RENESAS TECHNICAL UPDATE

Product Category	MPU & MCU	Document No.	TN-16C-A195A/E	Rev.	1.00
Title	Errata to R32C/153 Group Hardware Manual	Information Category	Technical Notification		
Applicable Product	R32C/153 Group	Lot No.	Reference Document	R32C/153 Group Hardware Manual Rev. 1.03 (REJ09B0505-0103)

This document describes corrections to the R32C/153 Group Hardware Manual, Rev. 1.03.
The corrections are indicated in red in the list below.

Figure 7.1 Clock Generation Circuitry

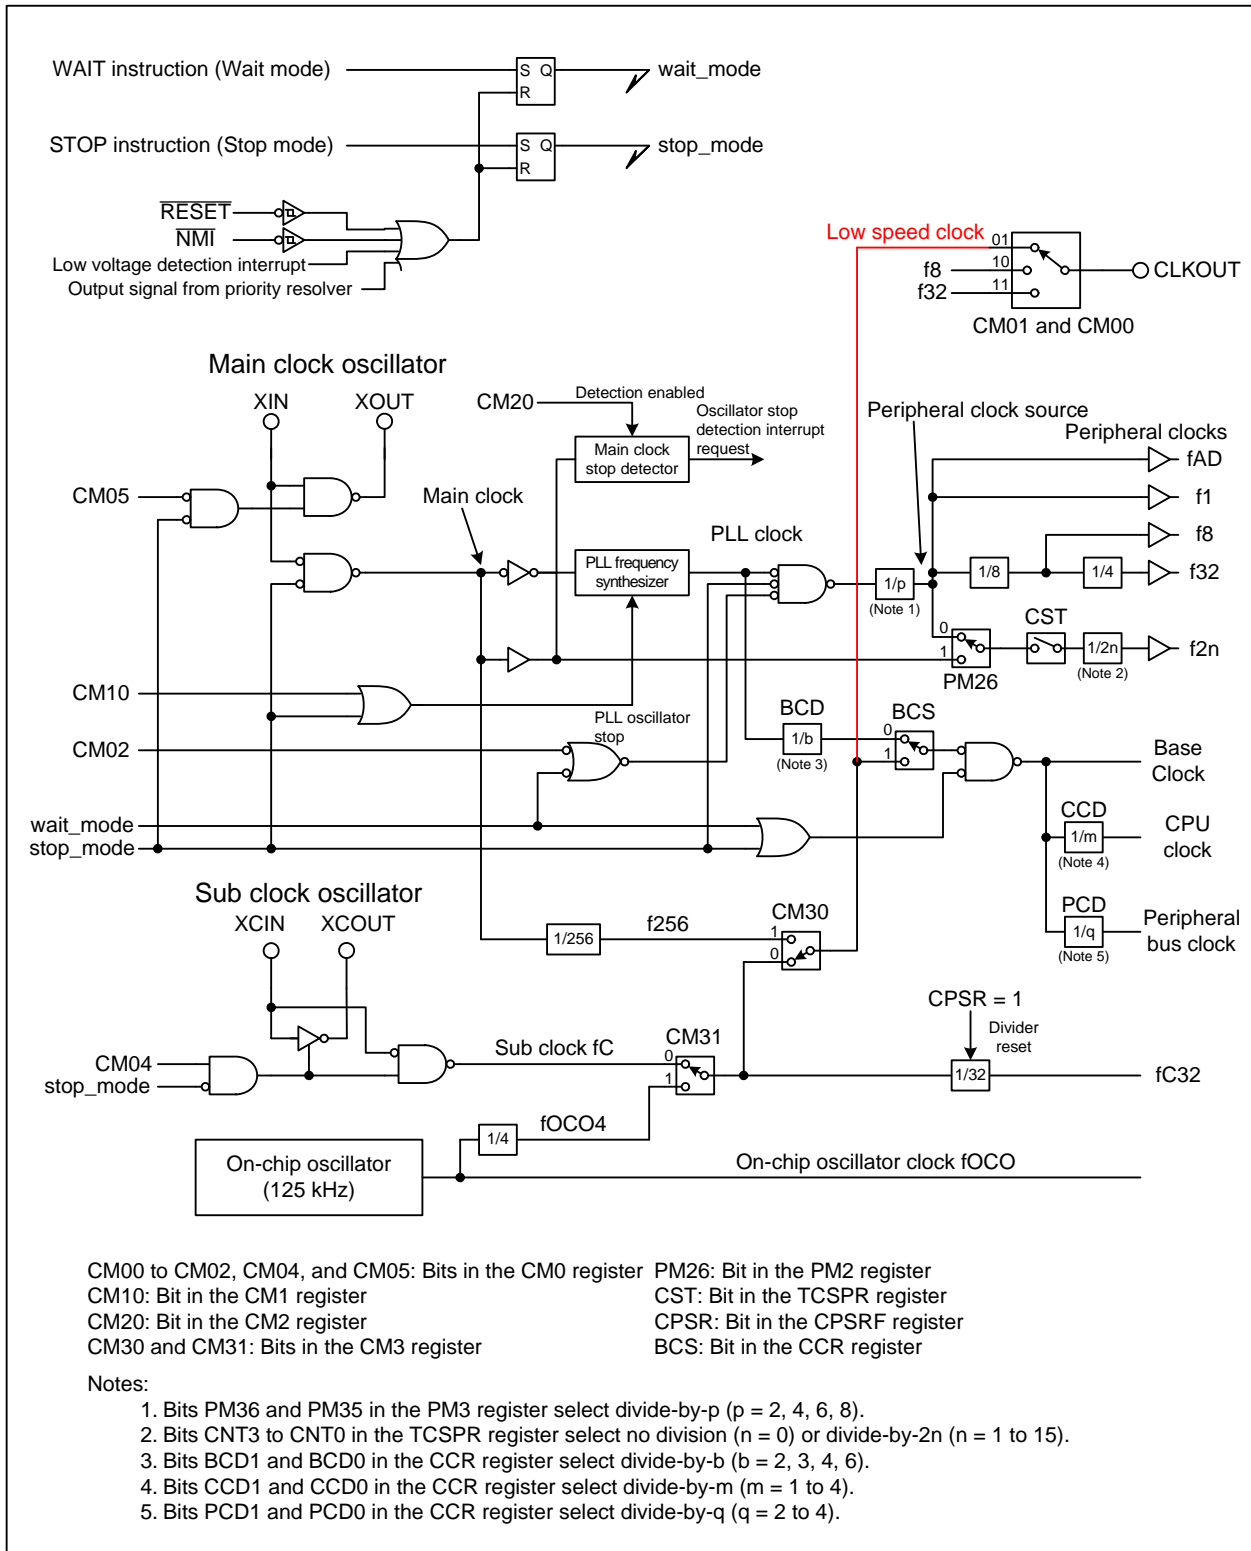
•Page 119 of 653, Figure 7.1 is corrected as follows:

Figure 7.20 State Transition (when the on-chip oscillator clock is used)

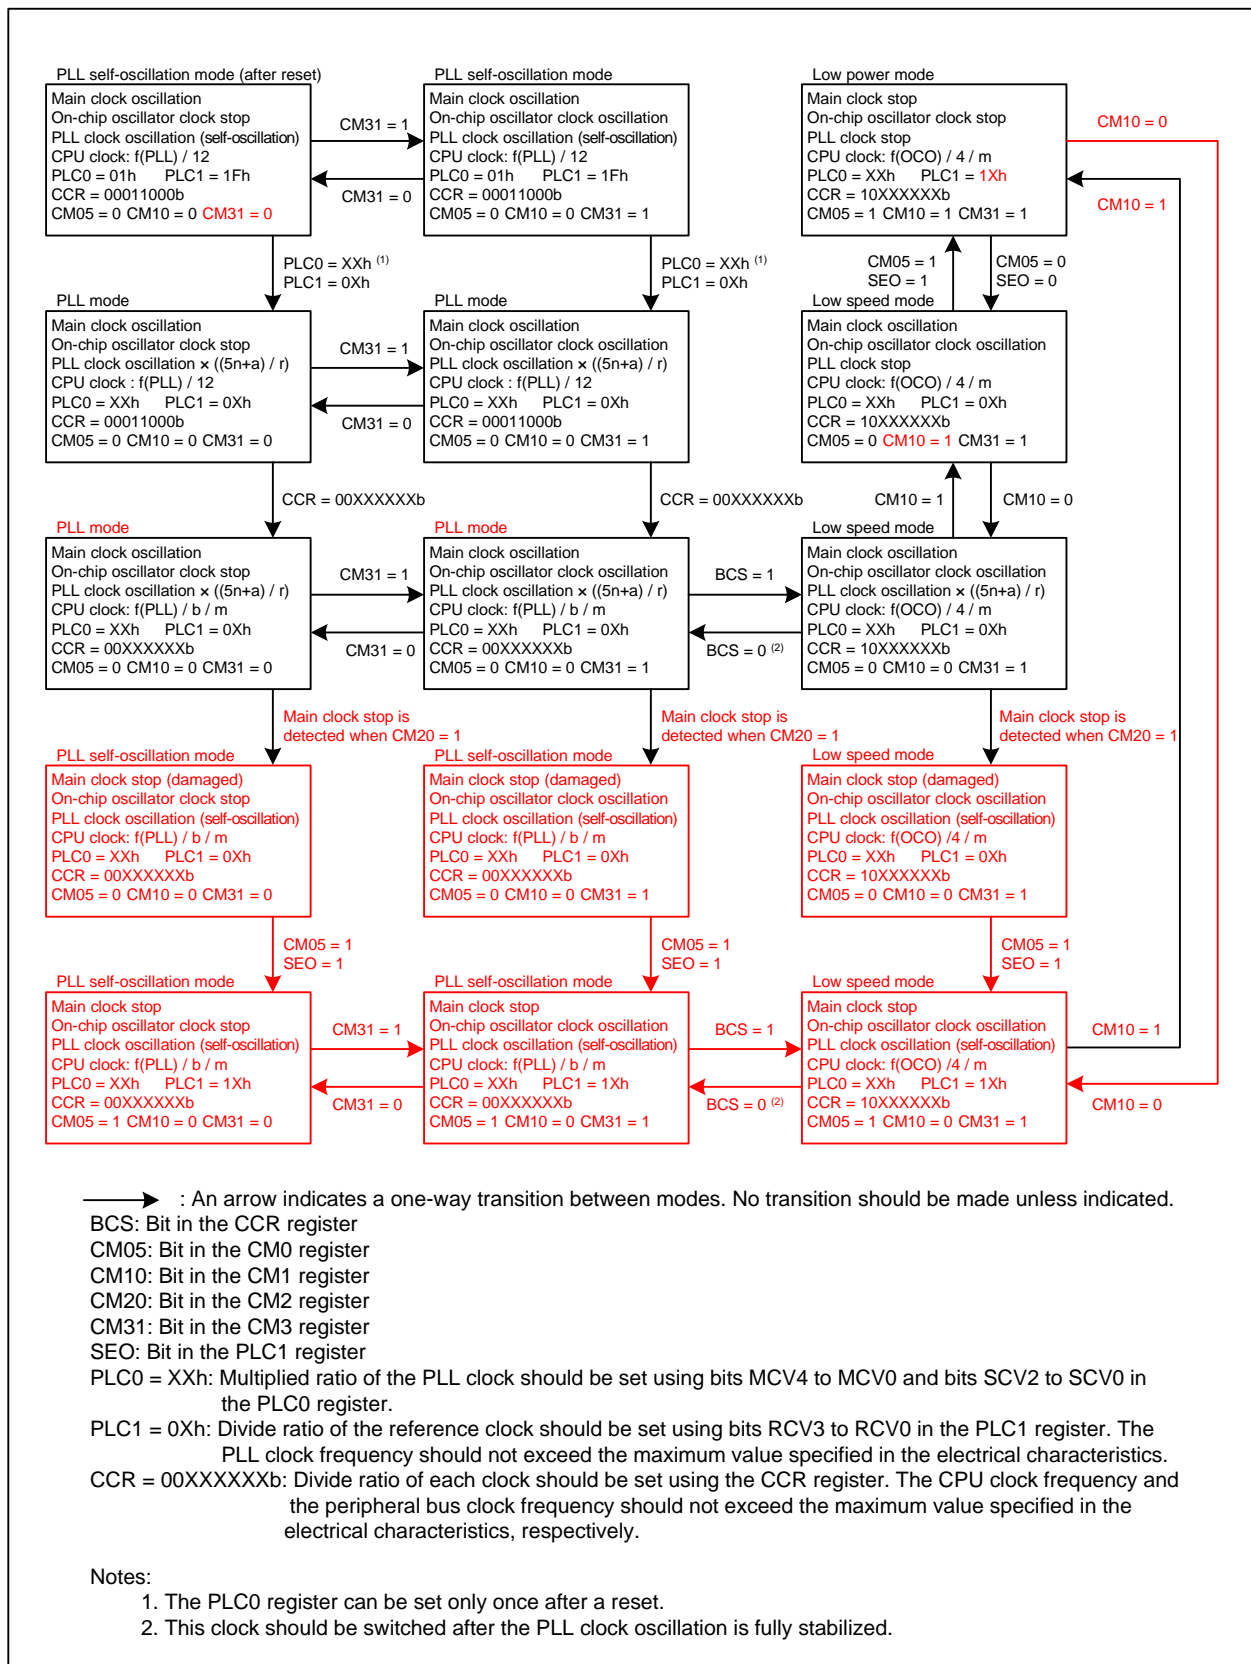
•Page 139 of 653, descriptions of “CM31 = 1” in the first row and “CM10 = 0” in the second row in Figure 7.20 are corrected, and the flowchart is clarified as follows:

(Note 3 “The CM05 bit is not set to 1 when an oscillator stop is detected through the oscillation stop detector.” is deleted from Figure 7.20)

Figure 10.8 Priority Resolver

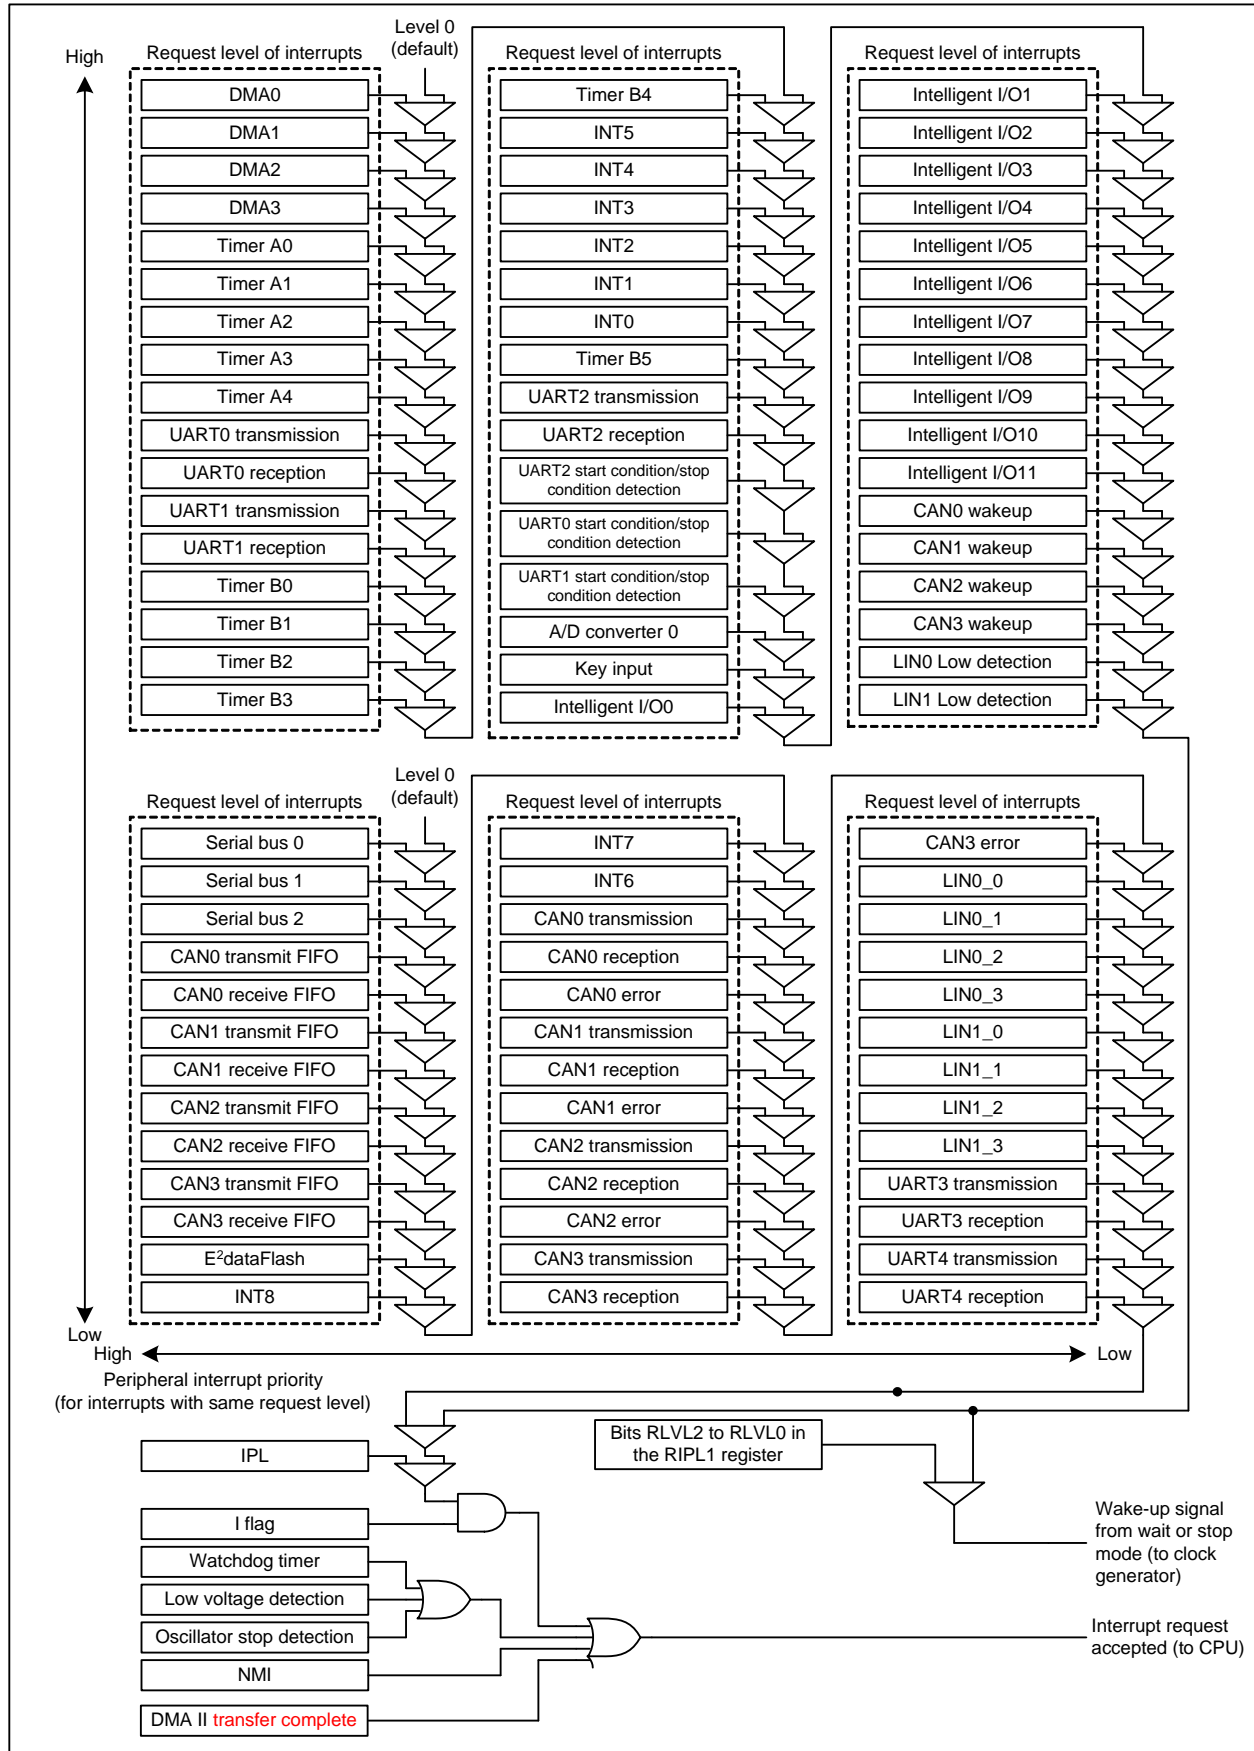
•Page 171 of 653, Figure 10.8 is corrected as follows:

(Description “Bits RLVL2 to RLVL0 in the RIPL2 register” and associated signal lines are deleted from Figure 10.8)

Figure 15.2 Timer B Configuration

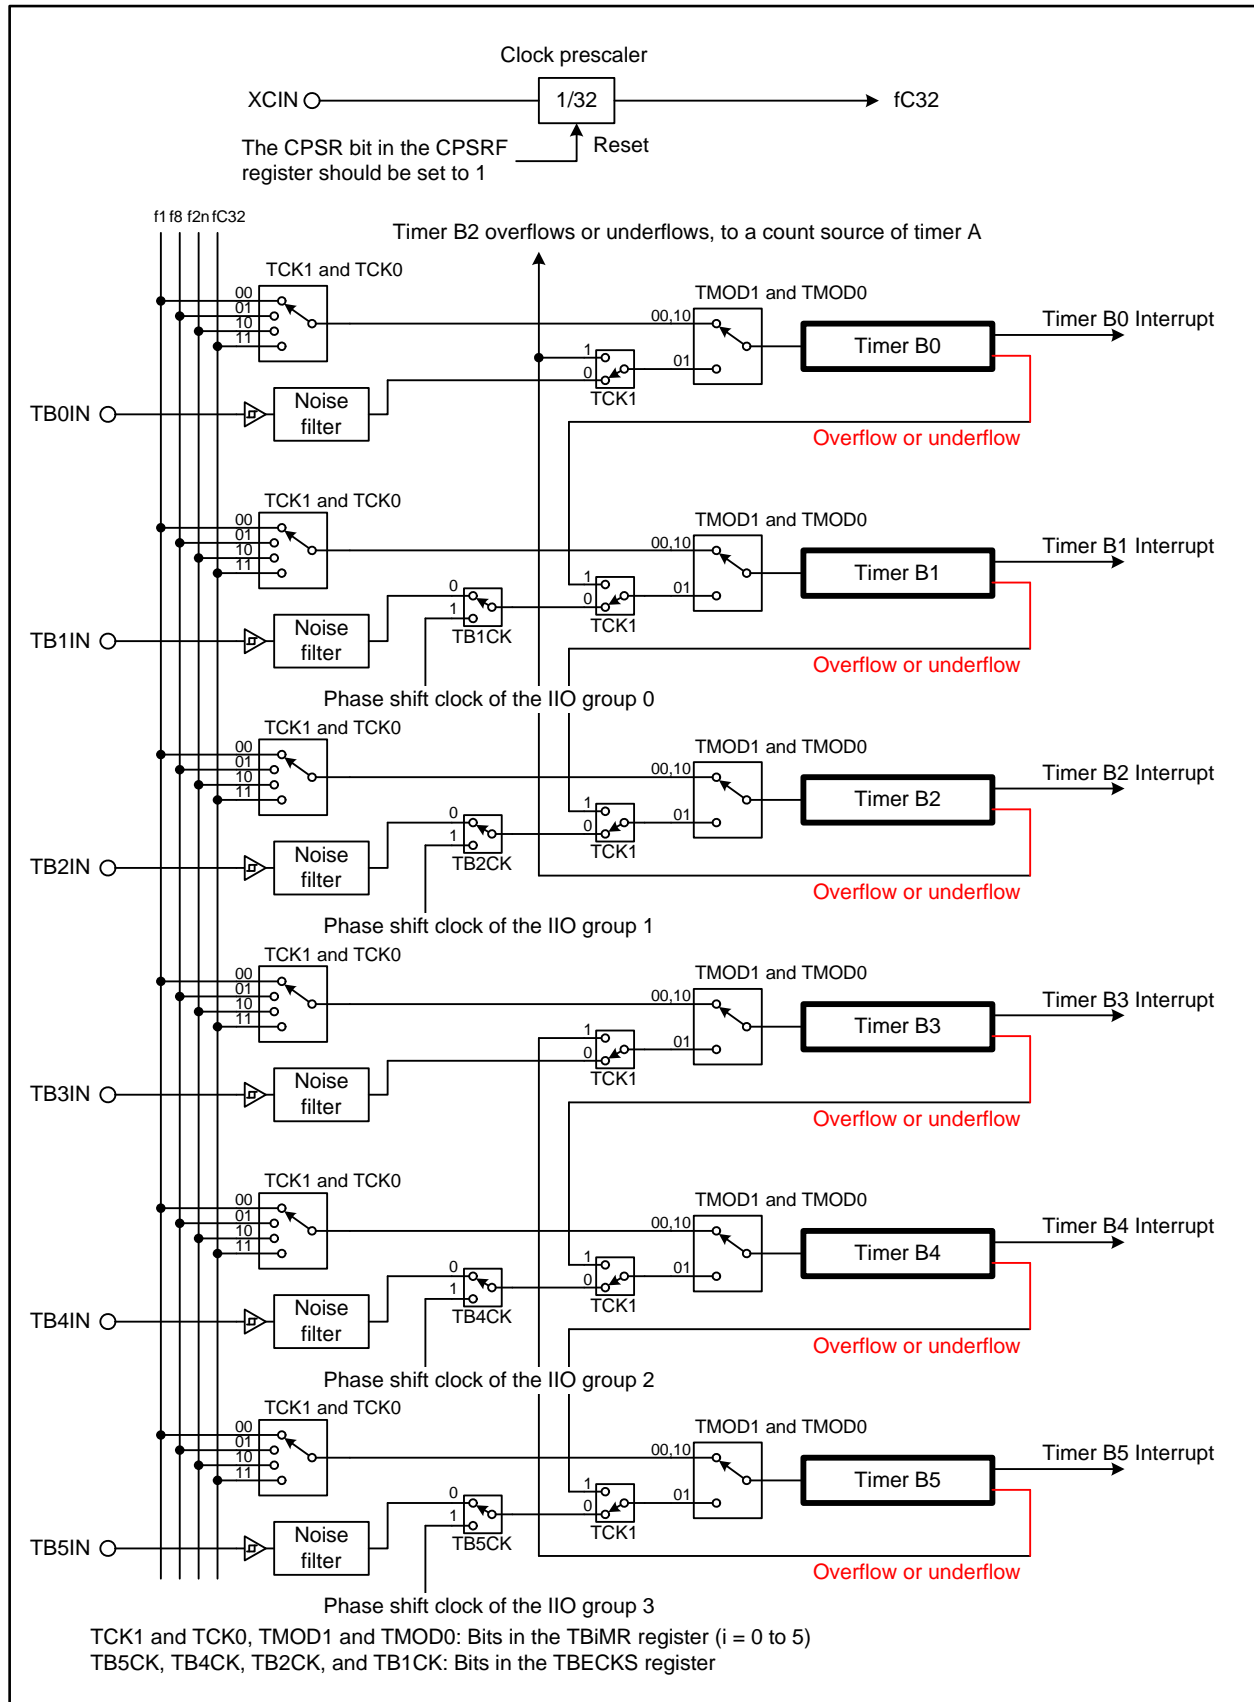
•Page 213 of 653, Figure 15.2 is corrected as follows:

Figure 24.30 Example of Setting Before Transmission to Wait Mode (i = 0, 1)

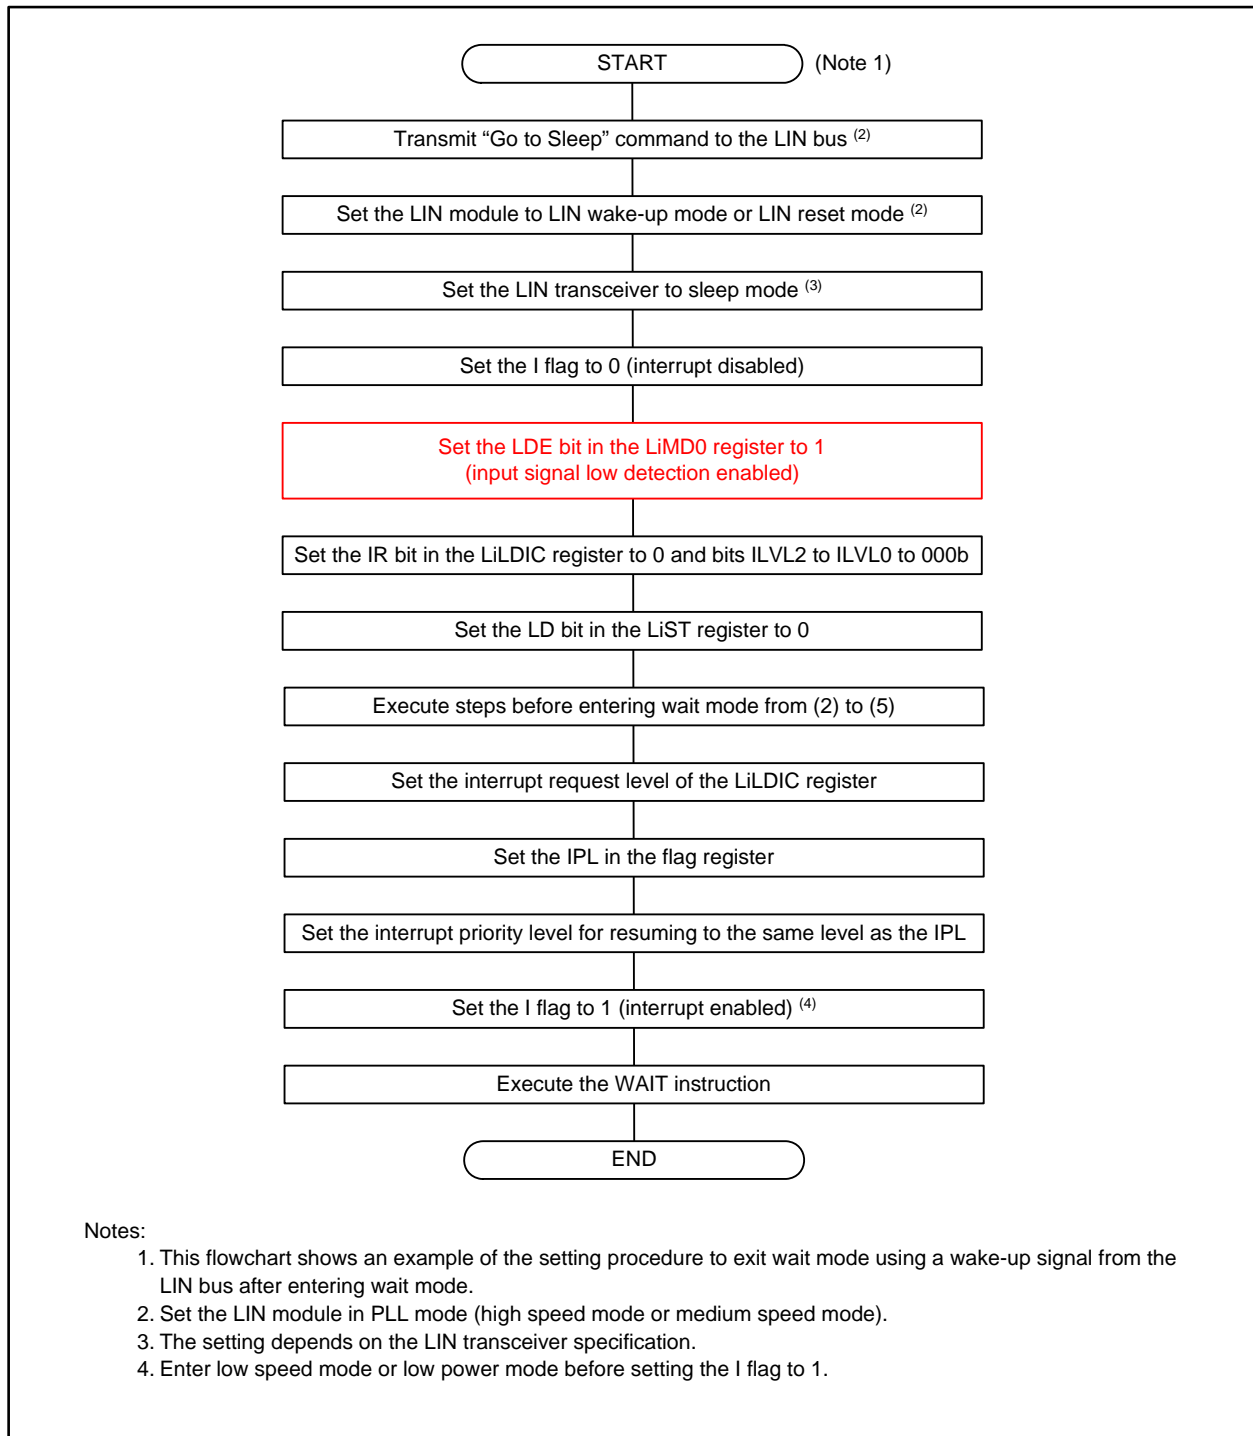
- Page 437 of 653, descriptions for (4) for “LIN Module Processing” in Table 24.5 are changed as follows:
 “Receive Data 2 due to start bit detection
 Receive Data 3 due to start bit detection
 (Repeat this process for the data length specified in bits RFDL3 to RFDL0 in the LiRFC register. Abort the reception and go to (5) if an error occurs. Checksum judgement is not performed in this case.)”
- Page 440 of 653, description “BPR0” in Note 1 of Table 24.6 is corrected as follows:
 “BRP0”
- Page 447 of 653, Figure 24.30 is corrected as follows:
